# USB Type-C ENGINEERING CHANGE NOTICE

## Title: FSM figure to text discrepancies

## Applied to: USB Type-C Specification Release 1.1.

### Figure 4-16 DRP with Accessory

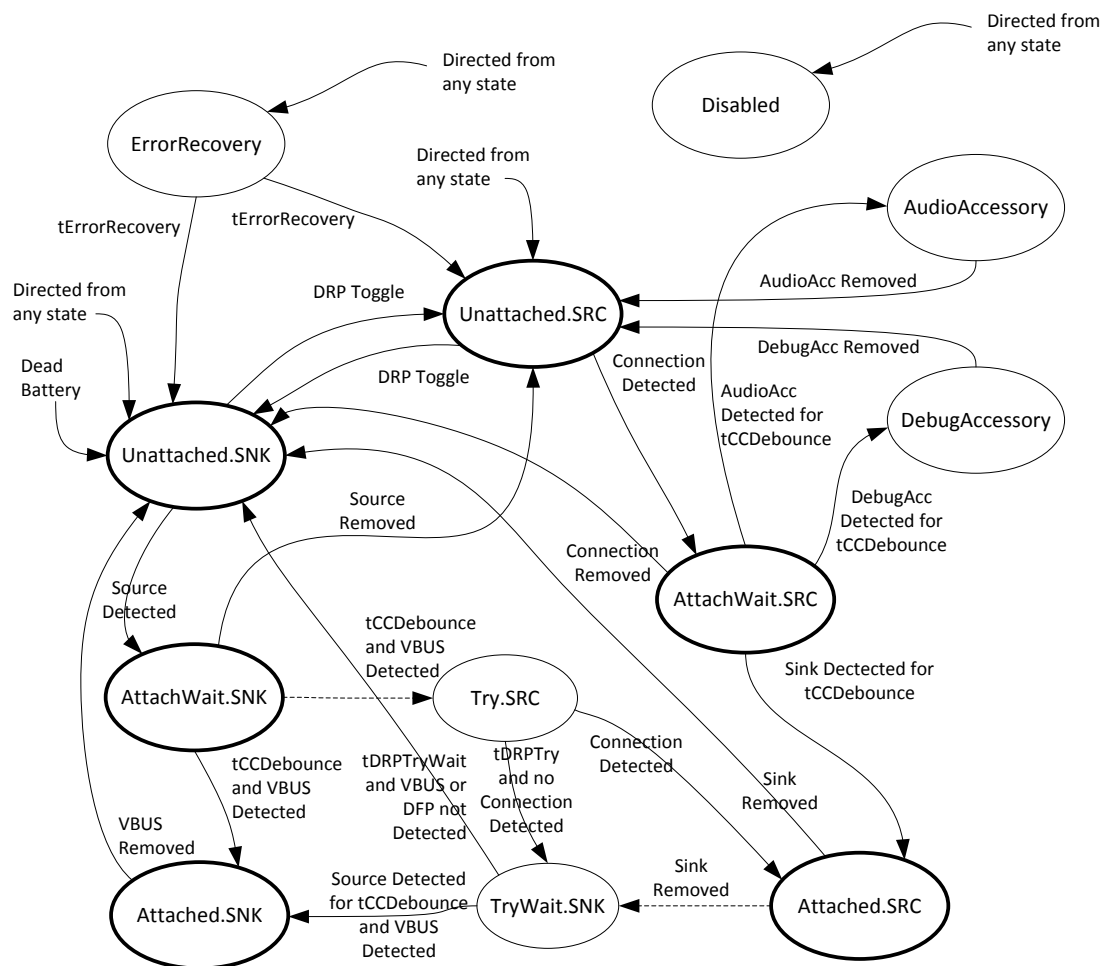
Figure 4-16, DRP with Accessory, shows the transition from Try.SRC to Attached.SRC with no debounce.

Figure 4-16, DRP with Accessory, shows the transition from AudioAccessory to Unattached.SRC with no debounce.

Figure 4-16, DRP with Accessory, includes VBUS not detected for exit from TryWait.SNK to Unattached.SNK.

Figure 4-16, DRP with Accessory, shows the transition from AttachWait.SNK to Unattached.SRC with no debounce.

Add tPDDebounce to Figure 4-16, DRP with Accessory, for the transition from Try.SRC to Attached.SRC.

Add tCCDebounce to Figure 4-16, DRP with Accessory, for the transition from AudioAccessory to Unattached.SRC.

Remove VBUS not detected from Figure 4-16, DRP with Accessory, for exit from TryWait.SNK to Unattached.SNK.

Add tPDDebounce to Figure 4-16, DRP with Accessory, for the transition from AttachWait.SNK to Unattached.SRC.
